REQUEST TO AMEND APPENDIX A OF FACILITY  
OPERATING LICENSES DPR-31 AND DPR-41...  
W/ATTACHMENTS

PLANT NAME: TURKEY POINT # 3 & 4  
SAB

Re: Turkey Point Units 3 & 4  
 Docket Nos. 50-250 and 50-251  
 Proposed Amendment to Facility  
Operating Licenses DPR-31 and DPR-41

REPORTABLE OCCURRENCE 250-77-5  
TURKEY POINT UNIT 3  
DATE OF OCCURRENCE: APRIL 18, 1977

Fig. 2.1-1. Reactor Core Thermal and Hydraulic Safety Limits, Three loop Operation

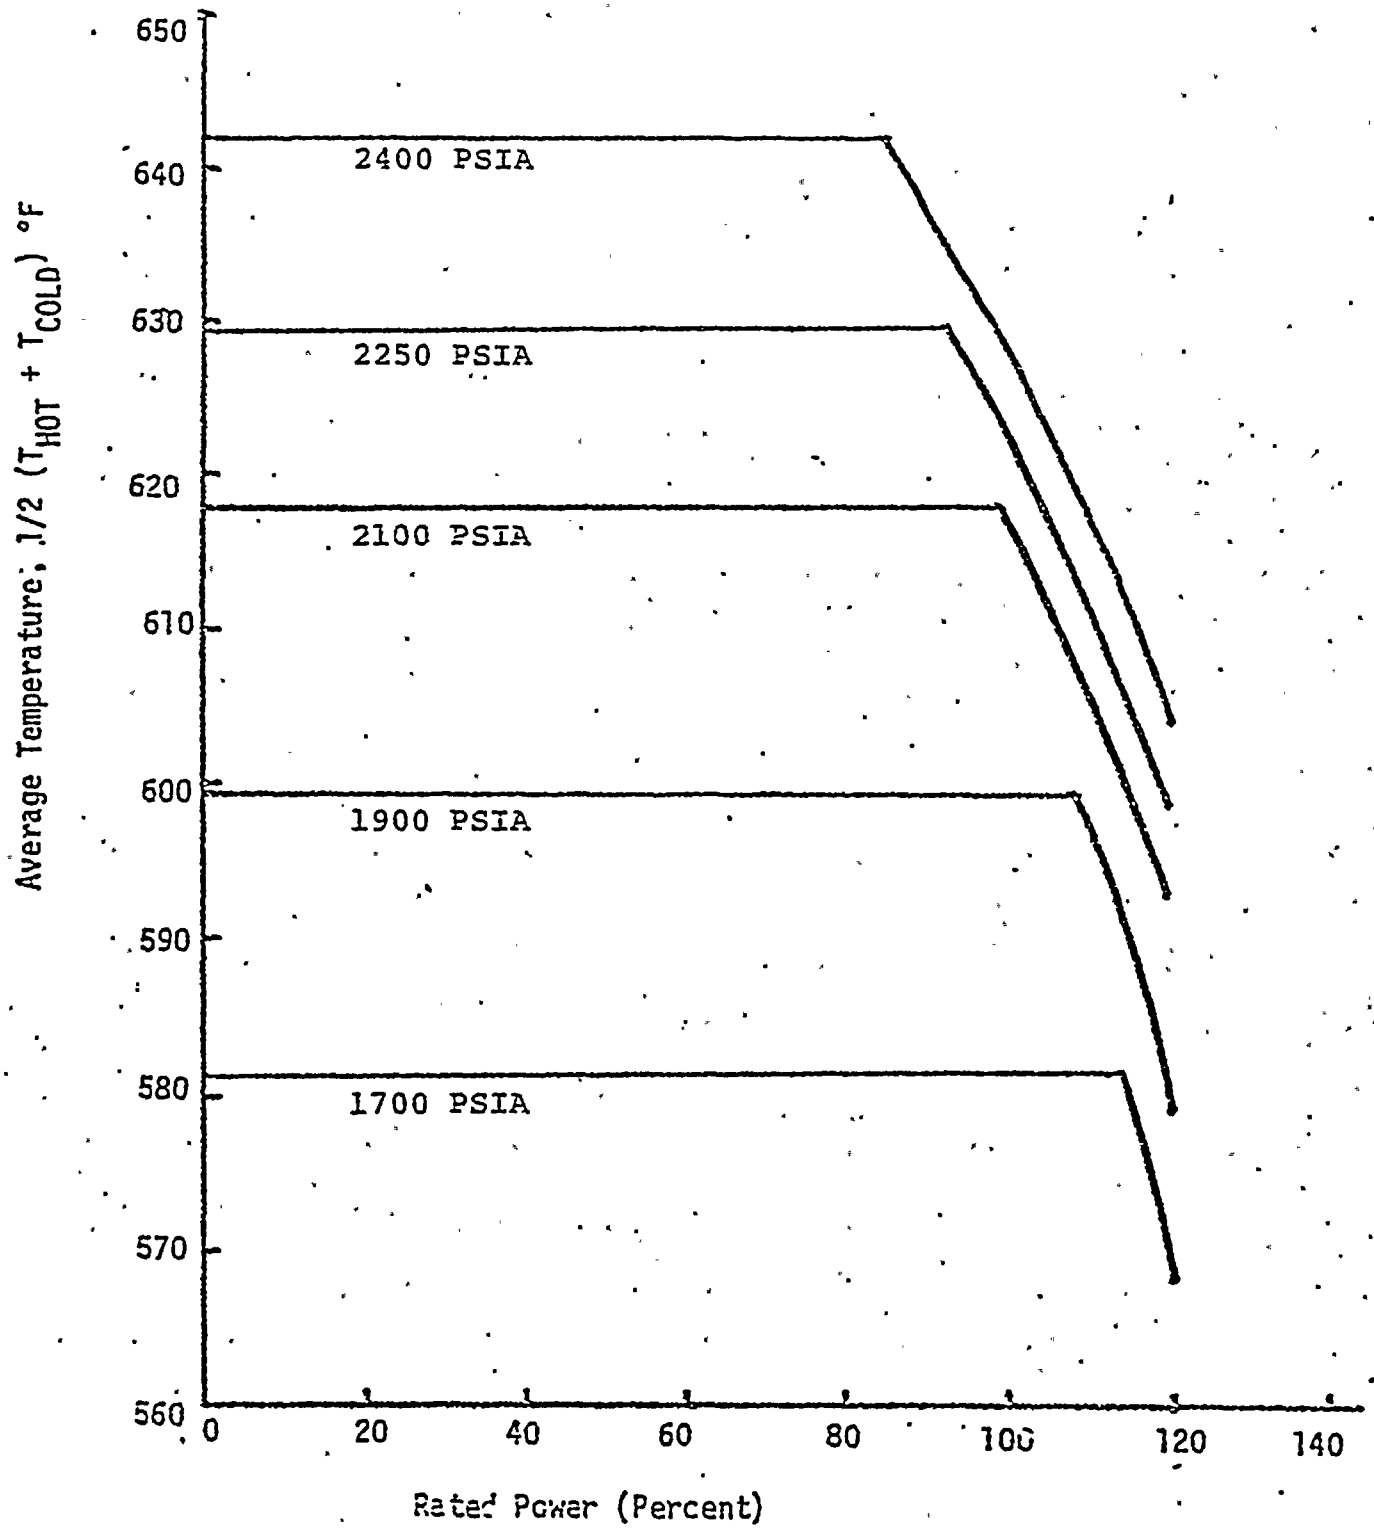
An analysis performed by our NSSS vendor has resulted in a corrected Figure 2.1-1 applicable at the licensed steady state reactor core thermal power output of 2200 Mwt.

012 | Discussions with our NSSS vendor have shown that Technical Specification Figure 2.1-1.
013 | "Reactor Core Thermal and Hydraulic Safety Limits", requires revision. An analysis
014 | performed at 2200 Mwt has yielded a corrected Figure 2.1-1 applicable to both Units 3
and 4. No changes to setpoints, operating limits, or operating practices are required
as a result of this correction. Neither unit has ever operated nonconservatively as a

power output. However, they recently advised us that the specific number being used for analytical work was 2192 Mwt. An analysis performed at 2200 Mwt showed that, in a single case, it would be necessary to make a minor administrative change to a Technical Specification (Figure 2.1-1). Figure 2.1-1 has been adjusted downward the necessary amount (approximately 1.5°F) to compensate for the correction. A proposed Technical Specification amendment will be submitted to the NRC to request a formal change correcting Figure 2.1-1.
